**CITY OF BATON ROUGE
PARISH OF EAST BATON ROUGE**

ADDENDUM NO. 3

**BATON ROUGE BUS RAPID TRANSIT PROJECT
(NICHOLSON DR. – FLORIDA BLVD. – PLANK RD.)
(CITY PARISH PROJECT NO. 16-CI-US-0032)**

ELECTRICAL CABINET DETAILS
NOT TO SCALE

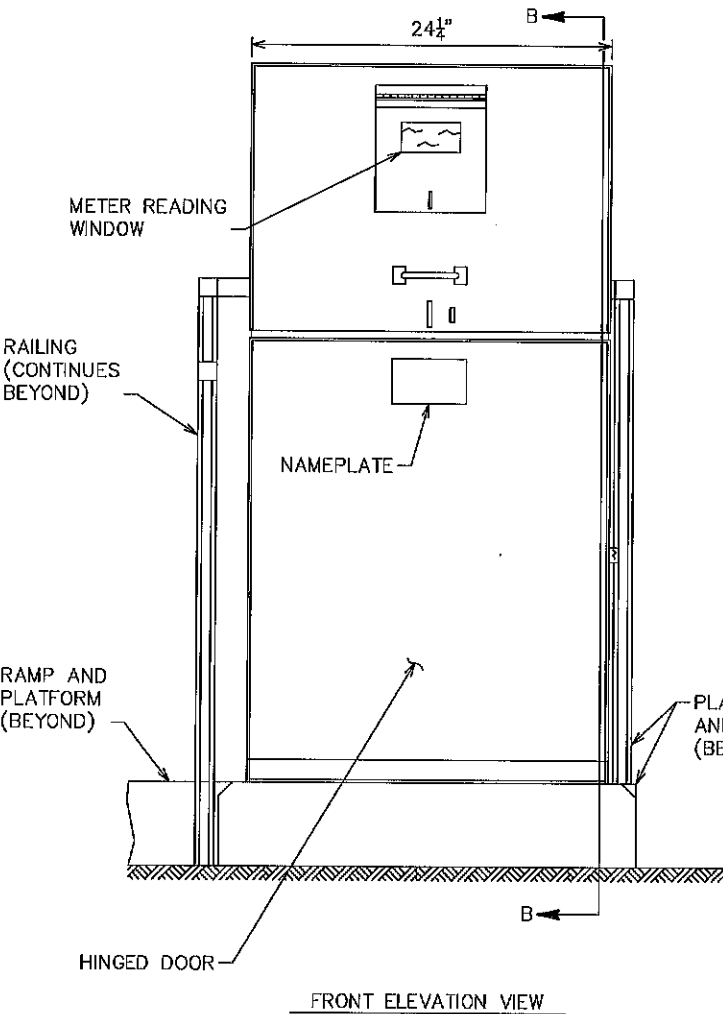
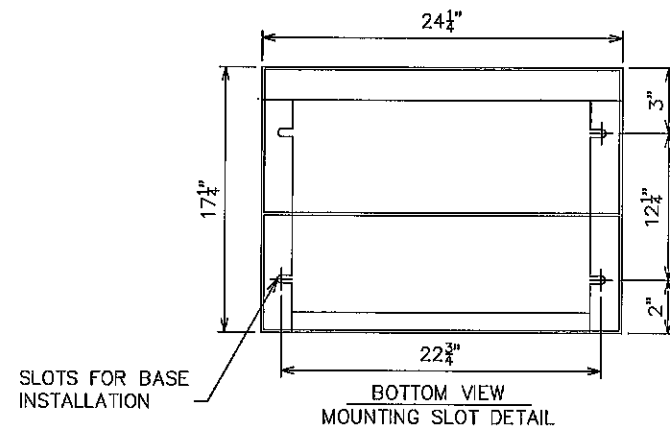
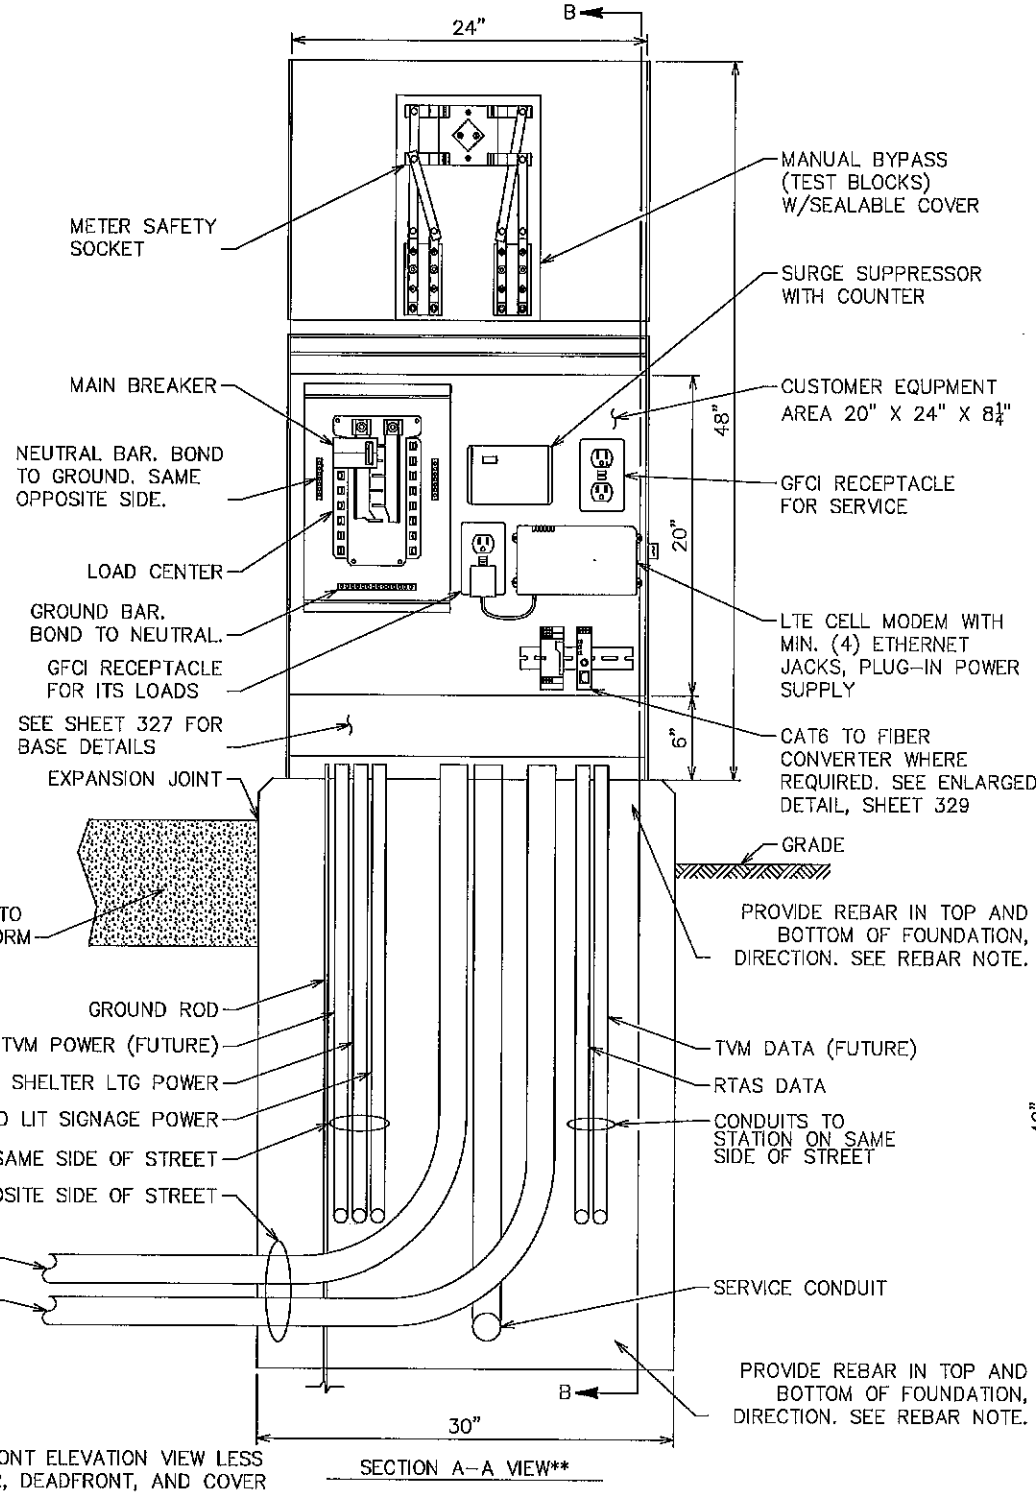
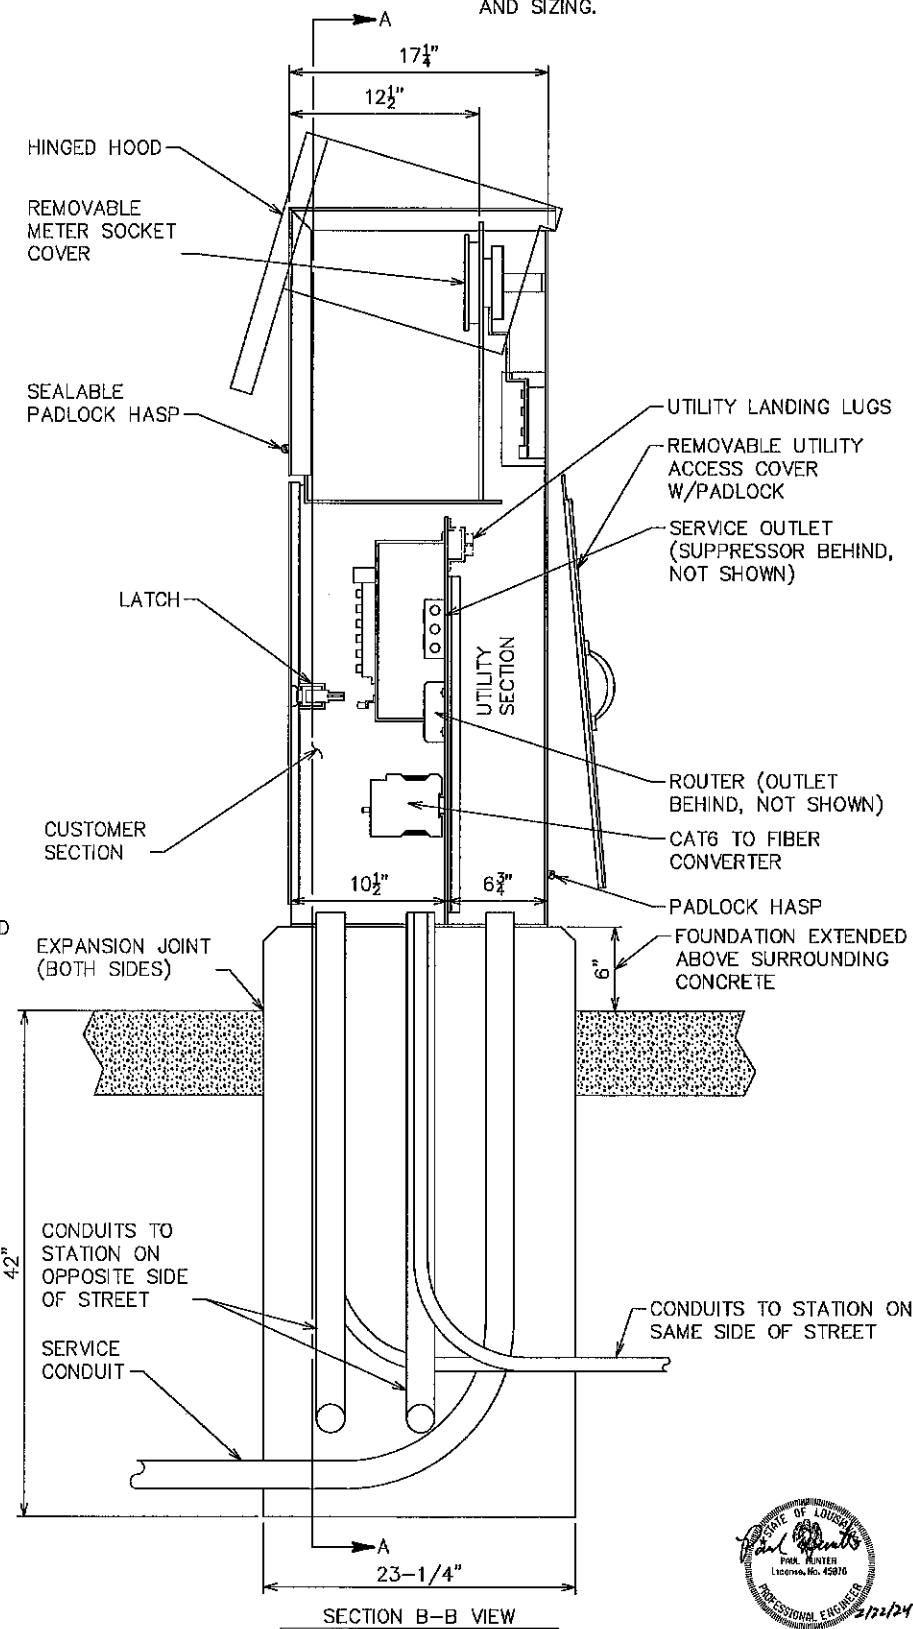
1. In the Station Electrical details there are two drawings numbered 328. Please confirm that all applicable pages have been supplied to bidders.

All applicable pages have been submitted. Electrical sheet 32 of 34 should be sheet no. 326. Revised sheet 326 included in this Addendum No. 3.

TRAFFIC SIGNAL MODIFICATION PLANS
 MAIN STREET AT SACRED HEART
 PLANK-NICHOLSON BUS RAPID TRANSIT

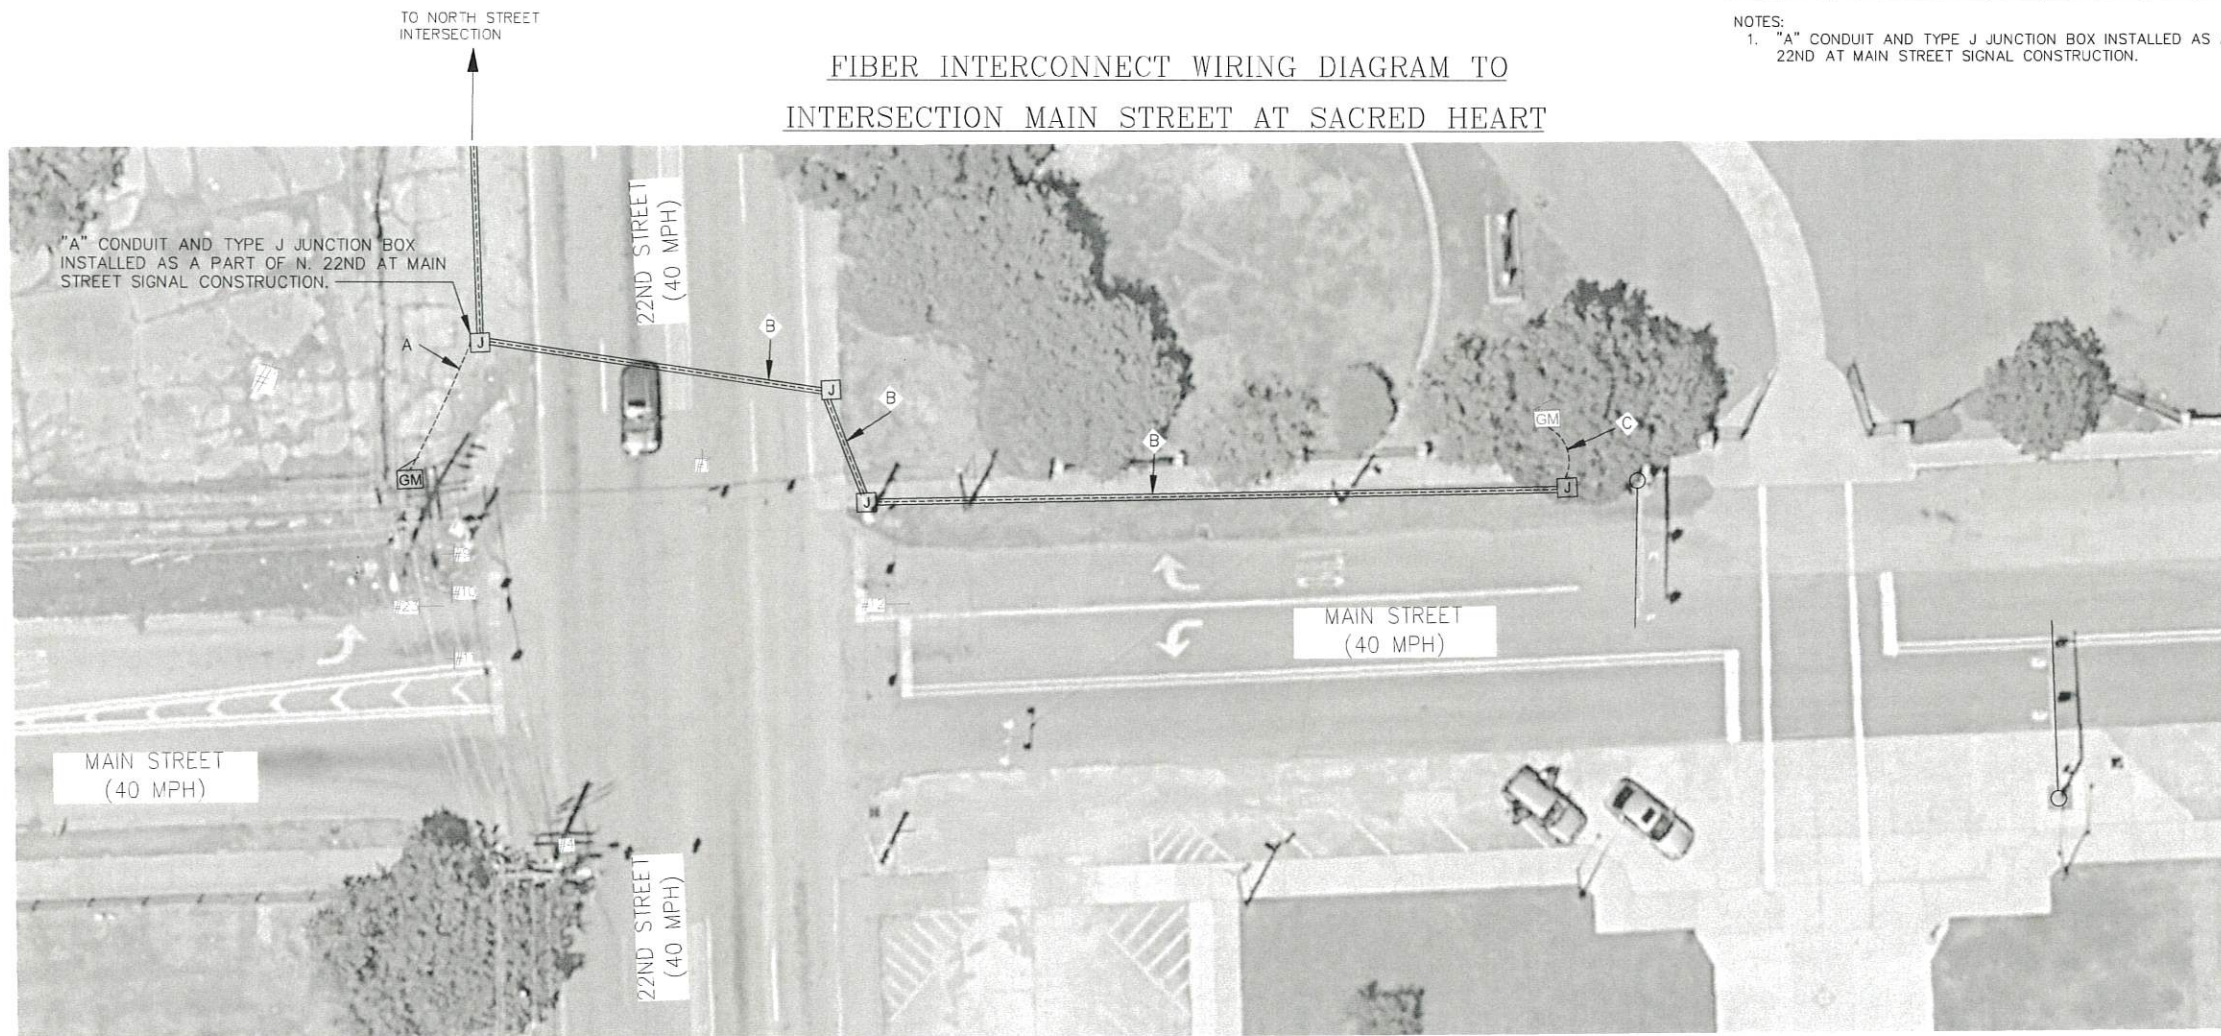
2. In the Traffic Signal Modification plans, drawing 440 is labeled as being sheet 2 of 3 for the intersection of Main St. & Sacred Heart. Sheets 1 and 3 of this sequence were not provided. Please confirm that all applicable pages have been supplied to bidders.

The Sacred Heart at Main Street sheet should be Sheet 1 of 1, not 2 of 3. Confirmed that all applicable pages have been supplied to the bidders. Revised sheet 440 in this Addendum No. 3.
